# **Determination 2006/103**

# Swimming pool fence at 33 Melchizedek Place, Dairy Flat, Auckland (to be read in conjunction with determination 2005/125)

#### Figure1: The swimming pool and associated facilities

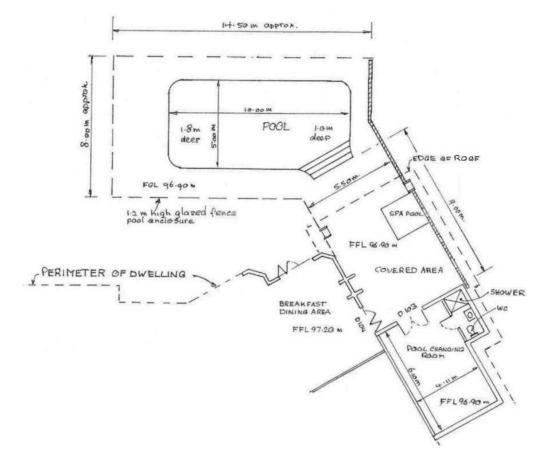
- 3.1 The relevant parts of the house and the swimming pool are shown in Figure 1. The only access to the swimming pool from the house is through a sliding-folding door ("D104") between the house and a covered area in which there is a spa pool. The covered area opens directly onto the swimming pool. Double doors ("D103") open outward from the covered area into a changing room.
- 3.2 Neither set of doors is self-closing.

- 5.1.3 In this Determination, the only difference is that door D104 is identified as a folding sliding door. Thus the only matter that I need to determine is whether that door complies with the Building Code even though it does not automatically close and latch. The territorial authority has made its submissions in that respect.

- (b) D104 comes within the exemption of clause F4.3.5(a) and is therefore not required to be self-closing and self-latching.
  - (c) Nevertheless, D104 is required to comply with clause F4.3.4(f) and "restrict the access of children under 6". The means of doing so cannot include self-latching and self-closing, but that does not prevent the use of other means, even if they are less effective than self-closing and self-latching.

- 5.4.3 In this case, there is no dispute that door D104 complies with clause F4.3.4(f) in that it is high enough, has small enough (if any) openings in it, and is sufficiently difficult for a child to climb. However, those are requirements that apply to the whole of the safety barrier and I consider that doors or gates need to include some additional means of restricting the access of children under 6.

- 6.1 In accordance with section 188 of the Act, I hereby:
  - (a) Determine that door D104 does not comply with clause F4, and
  - (b) Reverse the building certifier's decision to issue the code compliance certificate.
- 6.2 I am not required to, and do not, make any decision in respect of what is to be done to bring door D104 to compliance with clause F4 so that the territorial authority may issue a code compliance certificate.
